HKS PROJECT NUMBER
16246.000

ISSUE
CCD-049

SHEET TITLE
ROOF PLAN

SHEET TITLE
**ENLARGED
FACADE
ELEVATIONS**

SHEET NO.
AX2.11B

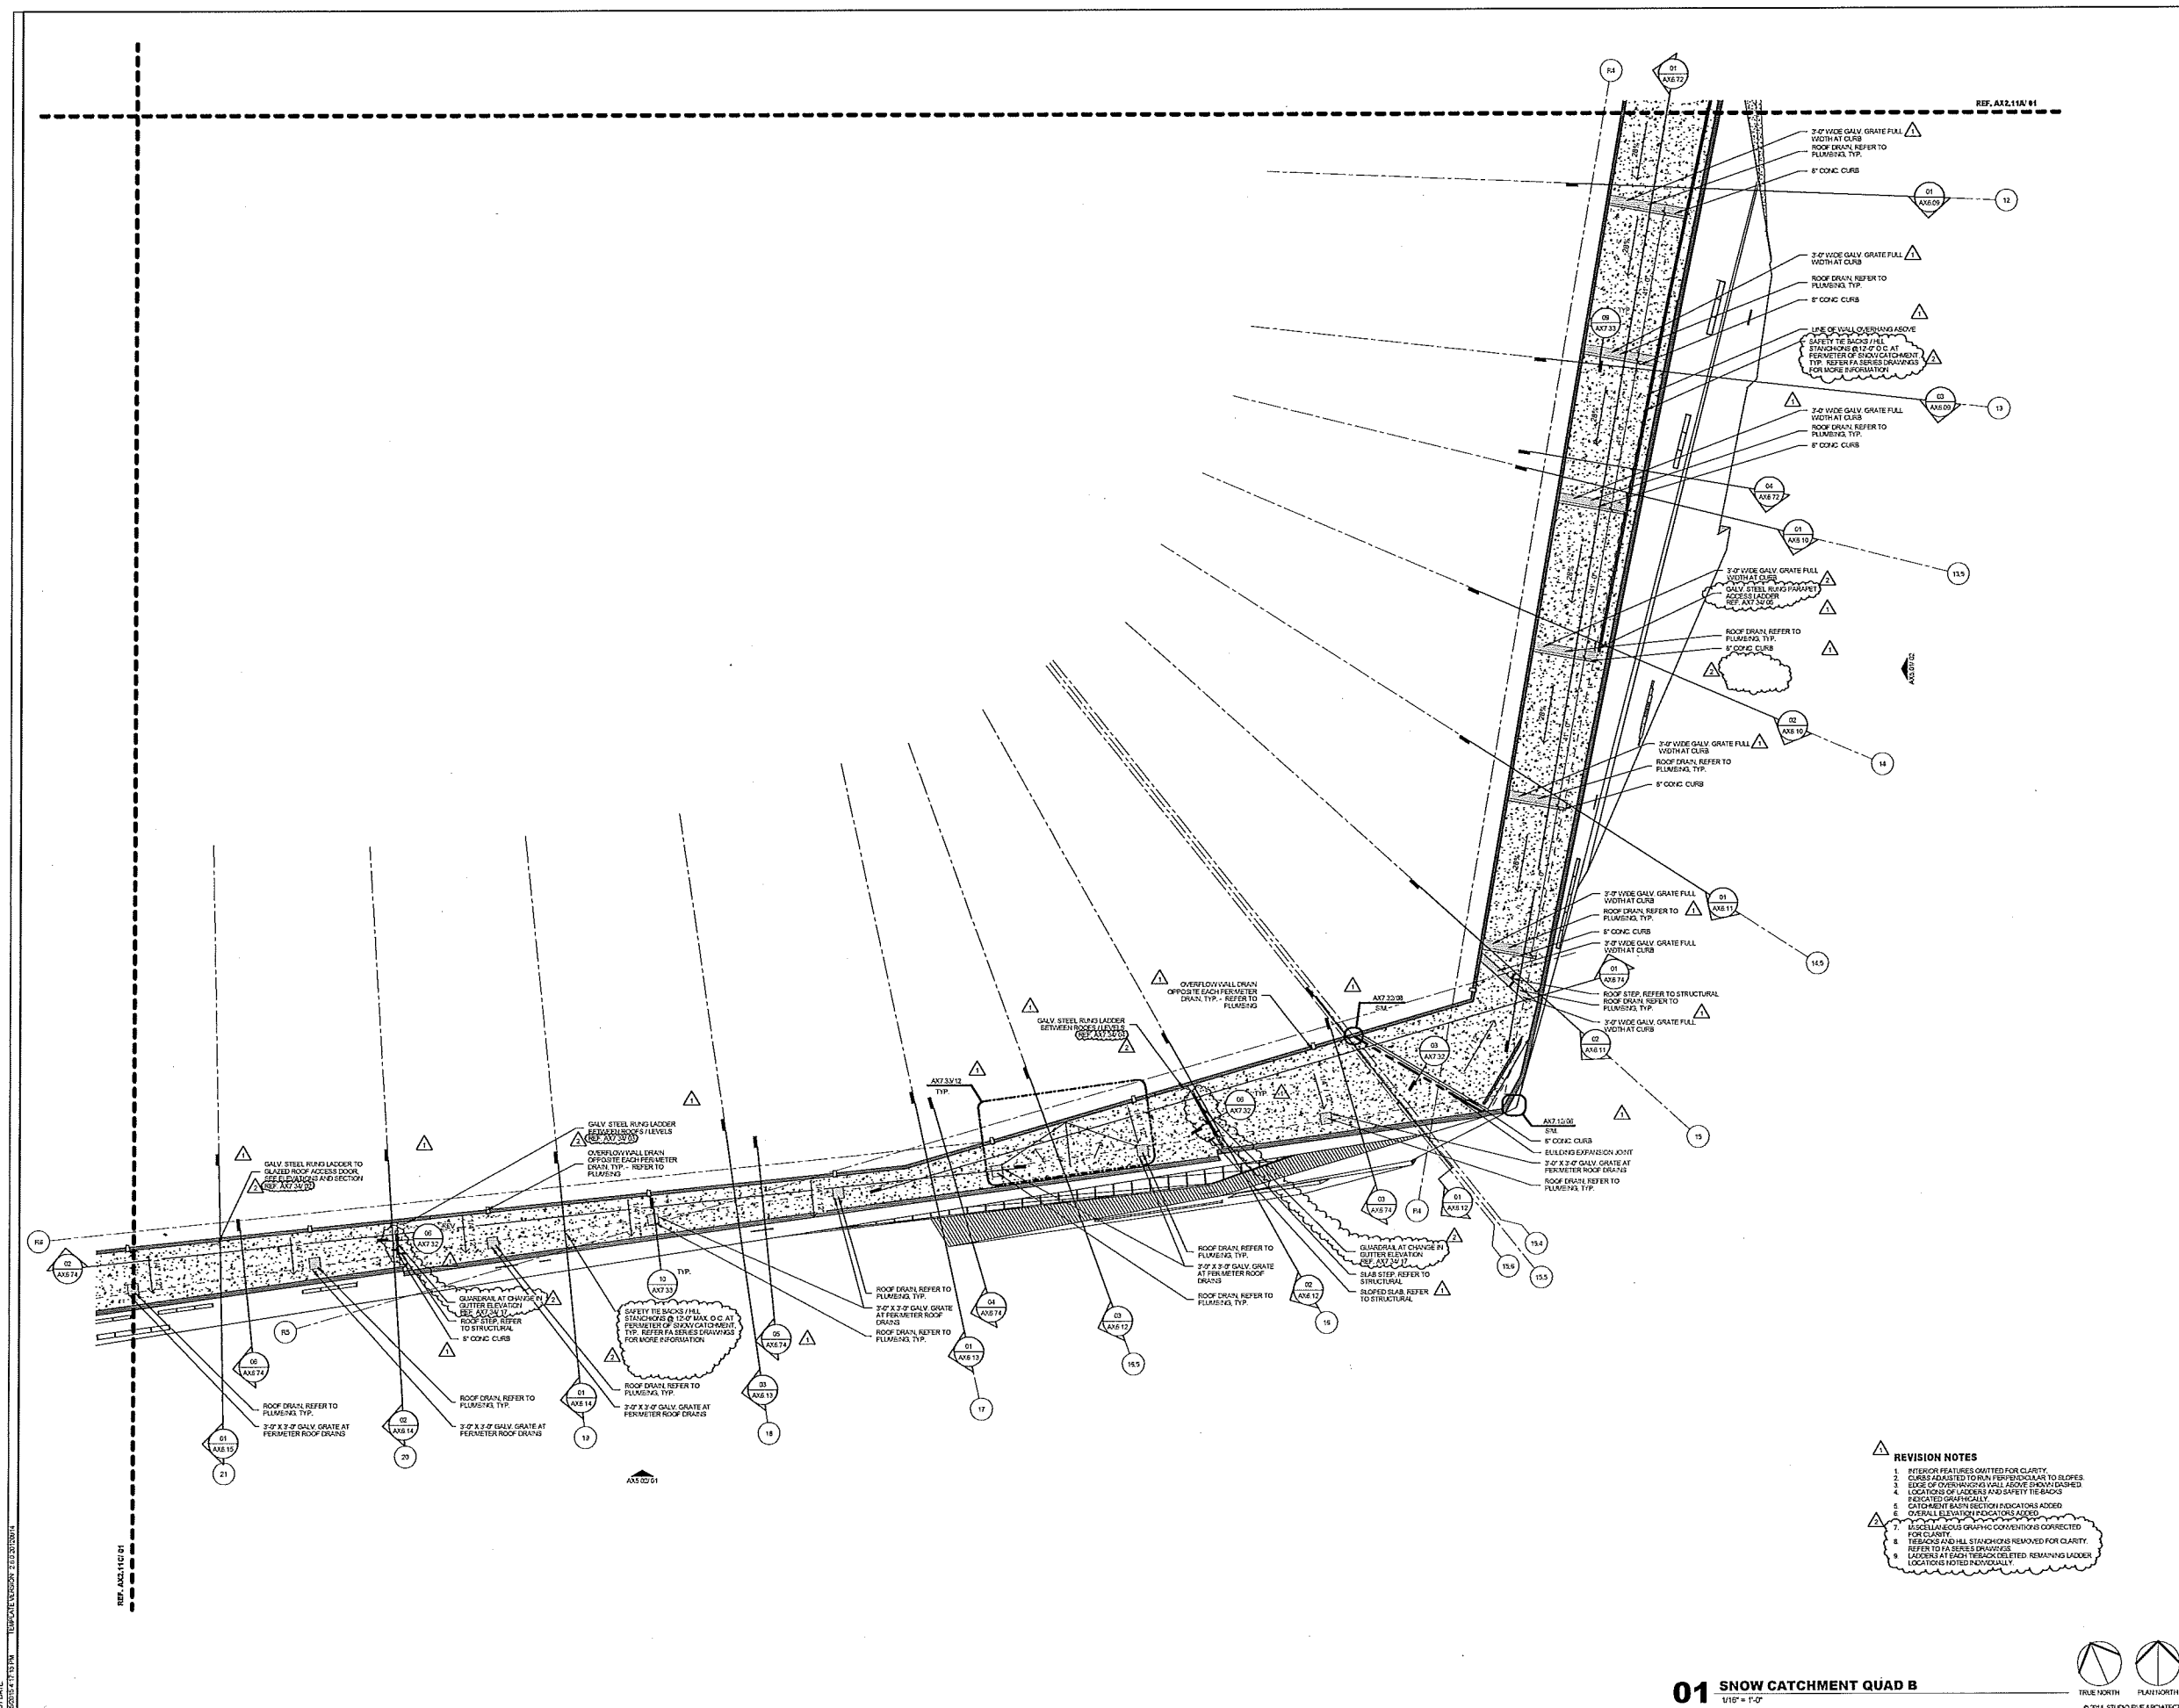
- REVISION NOTES**
1. INTERIOR FEATURES OMITTED FOR CLARITY.
 2. CURBS ADJUSTED TO RUN PERPENDICULAR TO SLOPES.
 3. EDGE OF OVERFLOW WALL ADJUSTED TO MATCH SLOPES.
 4. LOCATIONS OF LADDERS AND SAFETY TIE-BANDS RELOCATED GRAPHICALLY.
 5. CATCHMENT BASIN SECTION INDICATORS ADDED.
 6. OVERALL ELEVATION INDICATORS ADDED.
 7. MISCELLANEOUS GRAPHIC CONVENTIONS CORRECTED FOR CLARITY.
 8. TIE-BANDS AND HALL STANCHIONS REMOVED FOR CLARITY.
 9. REFER TO A SERIES DRAWINGS LOCATIONS AT EACH TRACK COLETTED. REMAINING LADDER LOCATION NOTED INDIVIDUALLY.

AX2.11C

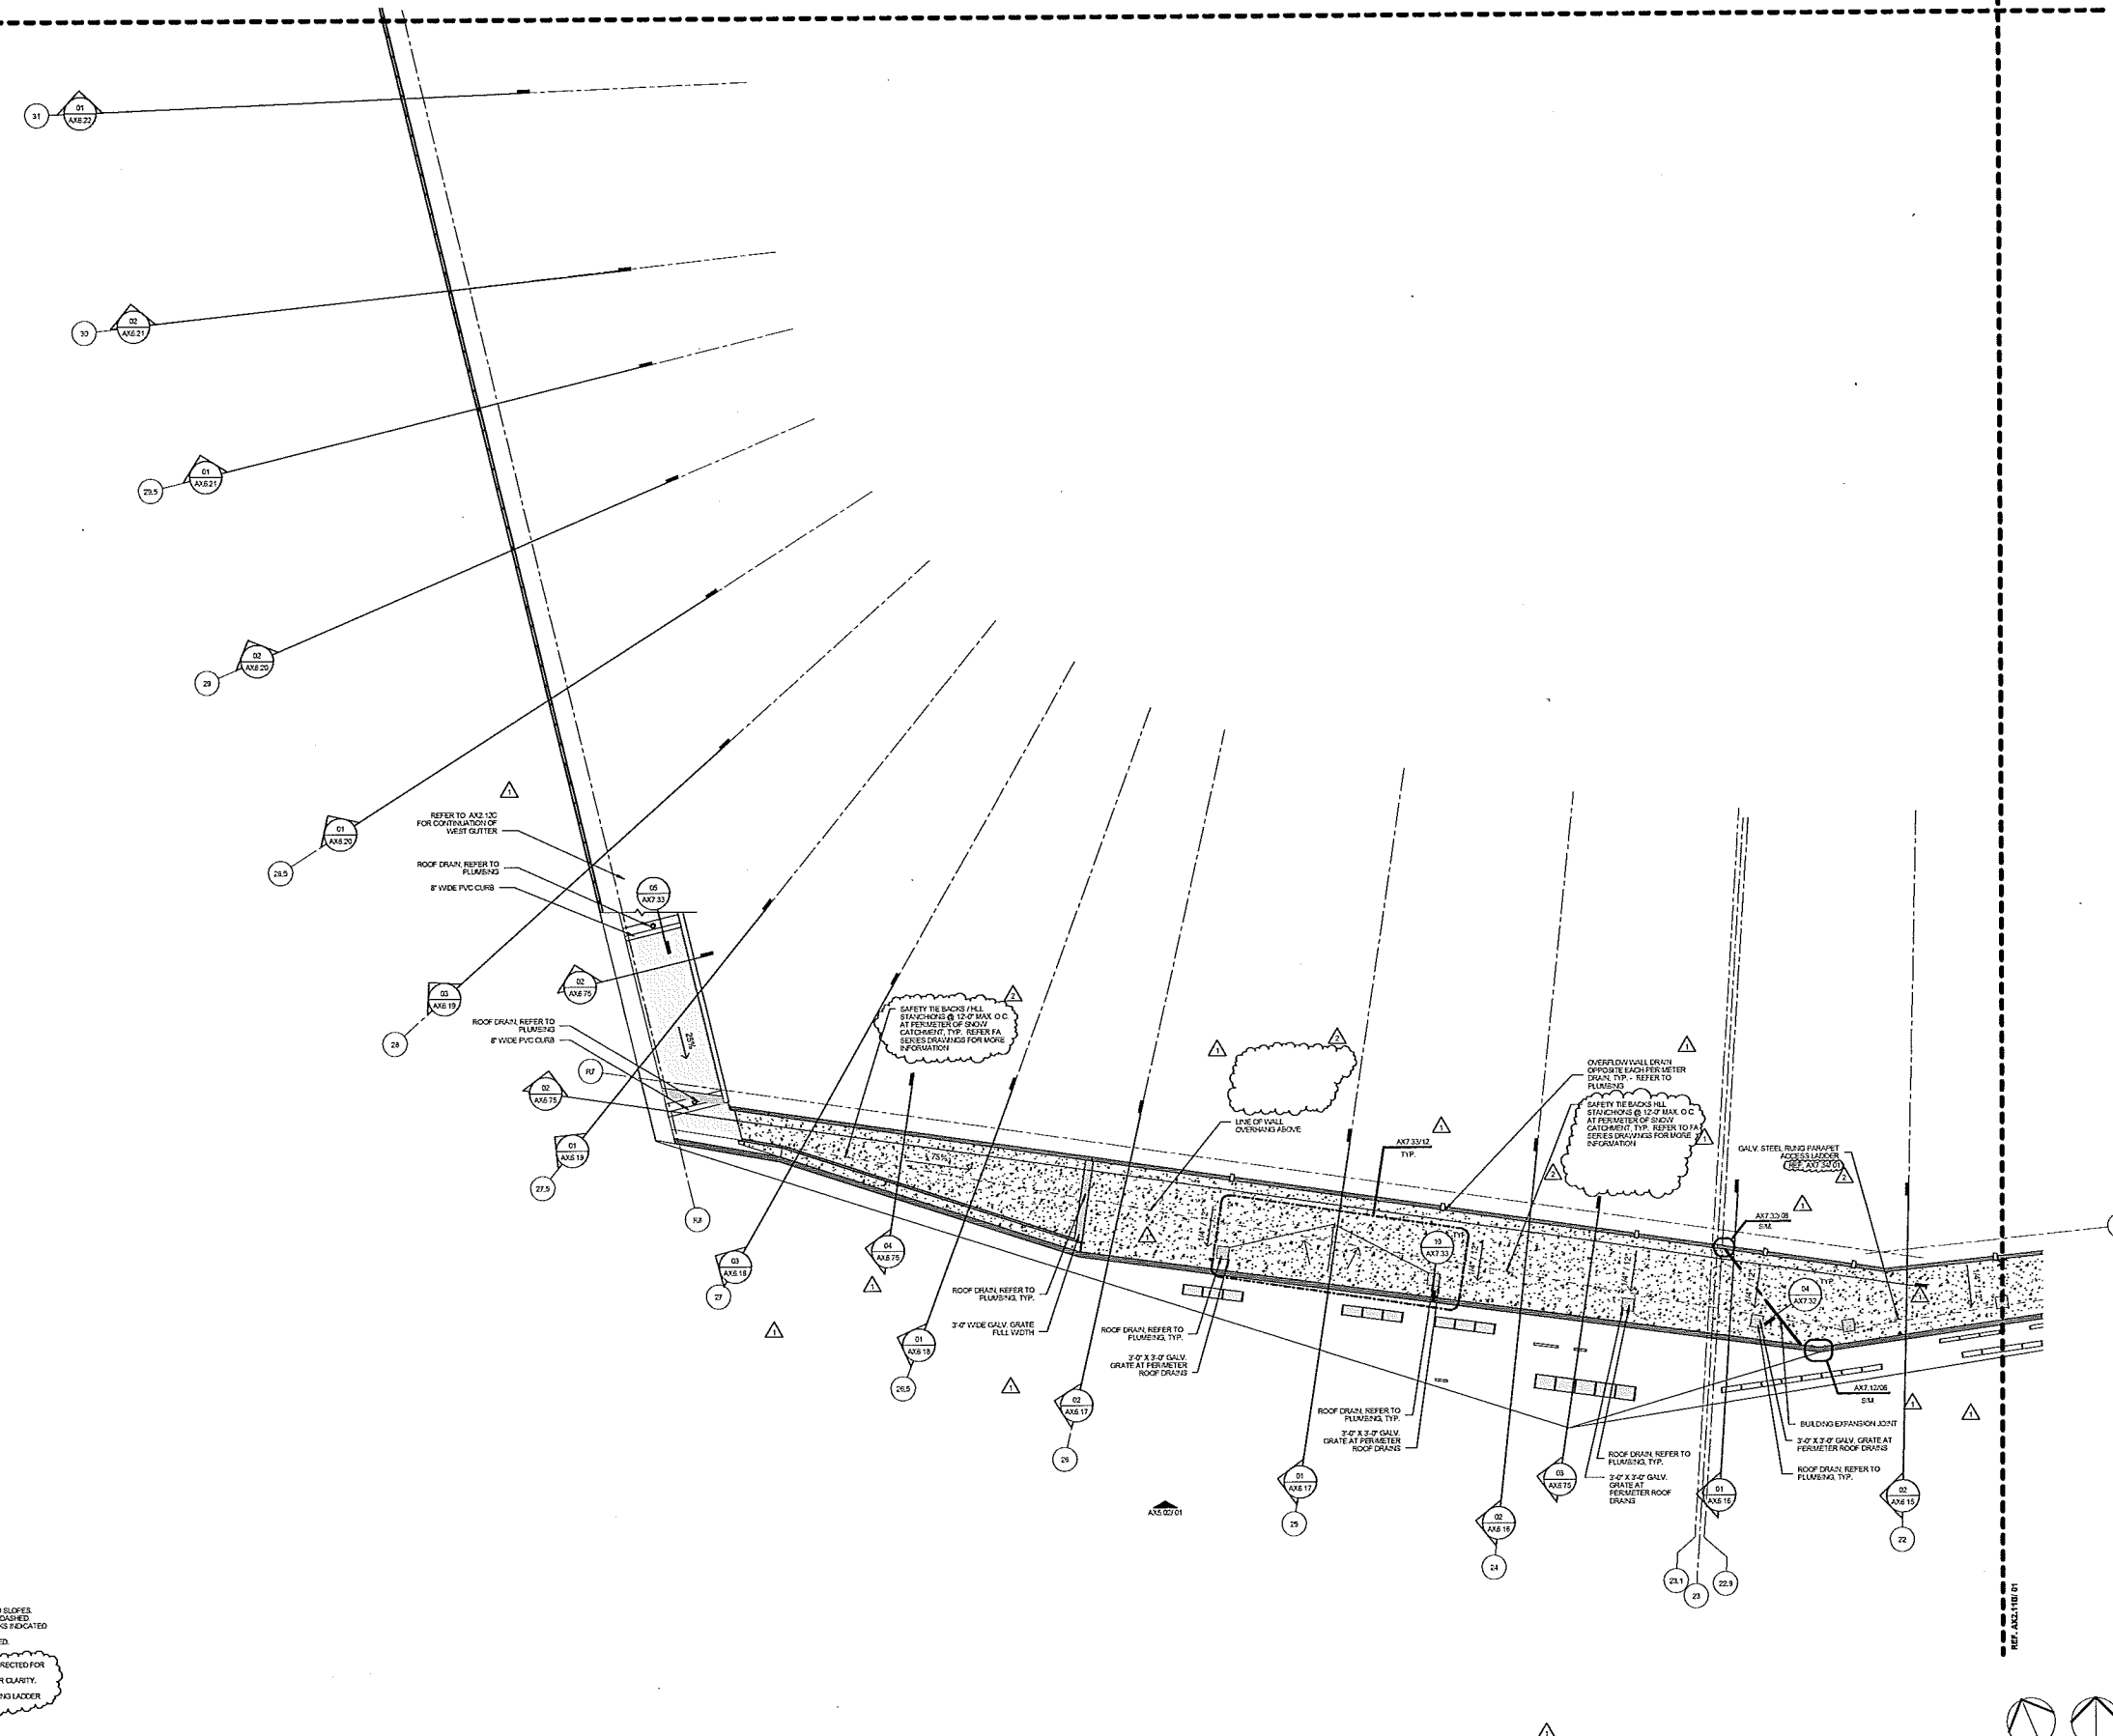
- REVISION NOTES**
- INTERIOR FEATURES OMITTED FOR CLARITY.
 - CURBS ADJUSTED TO BEA PERSPECTIVE TO SLOPES.
 - EDGE OF OVERHANGING WALL ABOVE SHOWN DASHED.
 - LOCATION OF LADDERS AND SAFETY BACKS HIGHLIGHTED GRAPHICALLY.
 - CATCHMENT BASIN SECTION INDICATORS ADDED.
 - OVERALL ELEVATION INDICATORS ADDED.
 - MISCELLANEOUS GRAPHIC CONVENTIONS CORRECTED FOR CLARITY.
 - TEEBACKS AND HILL STANCHIONS REMOVED FOR CLARITY. REFER TO A SERIES DRAWINGS.
 - LADDERS AT EACH TEEBACK DELETED REMAINING LADDER LOCATIONS NOTED INDIVIDUALLY.
